REQUEST FOR INFORMATION	DATE: June 20, 2016	NO.: RFI-176
--------------------------------	----------------------------	---------------------

Project Name: 15051-Webster University Interdisciplinary Science Building	Project No.: 15051
---	--------------------

Subject: Plumbing Stacks South of B-line, Levels 02, 03, and 04

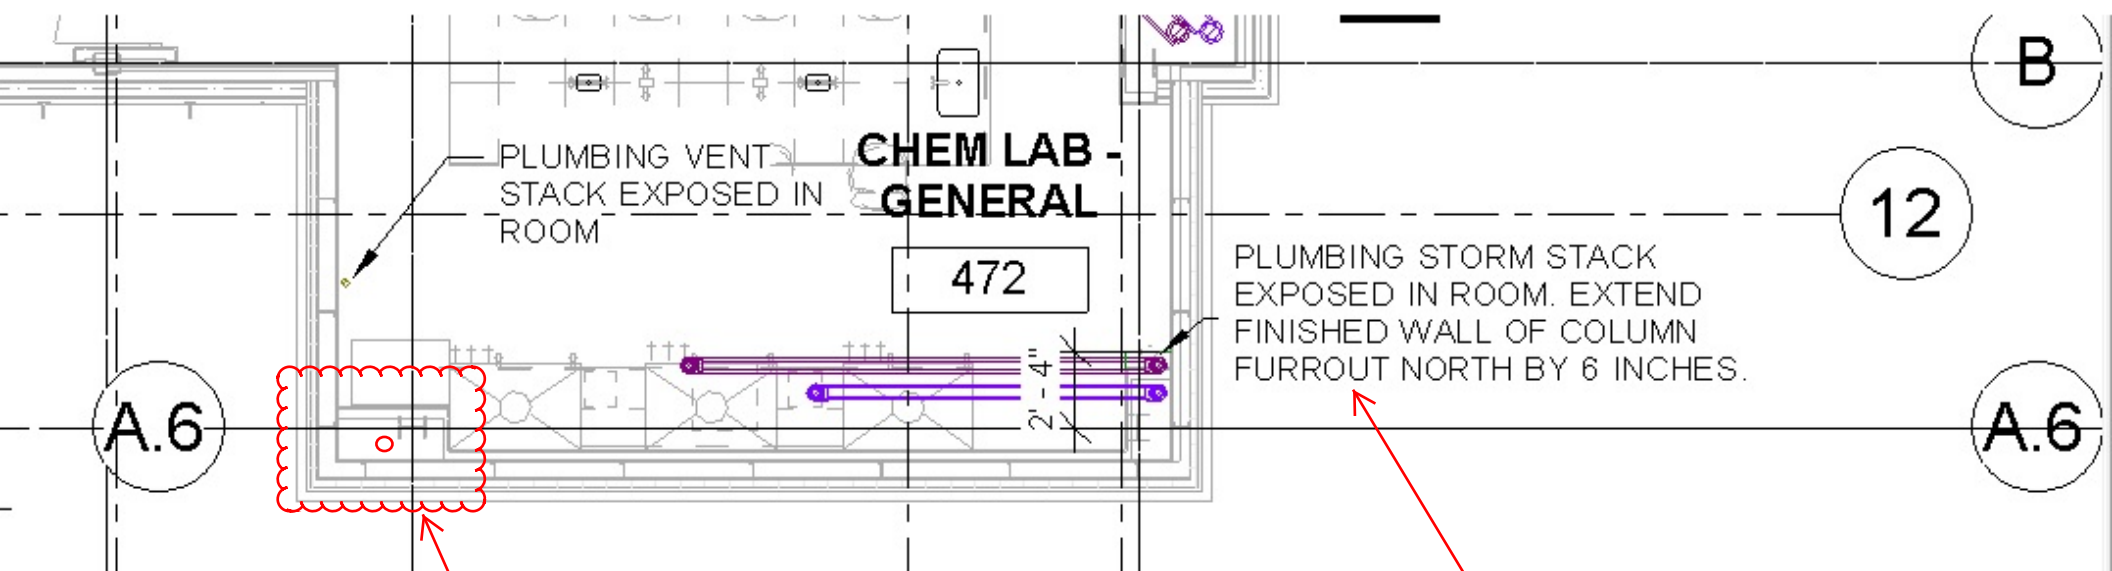
In Room 272A Chem Stock, there are two 3" plumbing sanitary stacks in the far West of the room. The plans show the stacks offsetting to the West as they rise up through the building. There is a steel element under the Level 01 slab which forces the plumbing stacks out to the indicated dimension (see attached) through the Level 01 slab. In the Level 02 space, there appears to be a type of shaft stud partition along the West wall of 272A. If the plumbing pipes are to offset to the West, tight to the West wall, they would be overlapping this stud partition as they travel up the building, and miss the steel elements in the Level 02 ceiling.

Please verify that it is acceptable to have the plumbing pipes overlapping this partition, or if the plumbing stacks should run straight up and down through the building at the indicated dimensions.

Room 372C – Two 3" plumbing sanitary stacks are exposed in the room, and conflict with shelving units. Shelves would have to shift 5 inches East to miss the plumbing stacks.

Room 372B – Two 3" plumbing storm stacks are exposed in the room. The column enclosure would have to be extended North, with the finished drywall at the dimension noted on the attached screenshot.

Room 472 – 3" plumbing vent stack is exposed in the room. It is a far distance from any adjacent corner. Please confirm this exposed pipe is acceptable. There is also an exposed storm stack. The finished wall of the column enclosure would need to shift 6 inches North to the dimension indicated.

EXPOSED VENT
STACK IN LEVEL 04
ROOM 472

EXPOSED STACKS IN LEVEL
03, ROOM 372C, CONFLICTING
WITH SHELVING

OFFSET TO OVERLAP
PARTITION ABOVE CEILING

EXPOSED STACKS IN
LEVEL 02, ROOM 272A

STACKS COMING UP
0' - 11 7/8"
THROUGH LEVEL 02 SLAB

OFFSET STACKS TO MISS
STEEL SUPPORTING
LEVEL 02 SLAB

The two 3 inch risers on the west wall have been shifted to the south, to run within the furred out space around the column.

The Architect is addressing the furred out spaces along the east wall

Refer to notes on the attached sketches.

This will be addressed in an up coming ASI.

Plumbing risers will be shifted to extend within the furred out space around the column

The Architect is addressing this
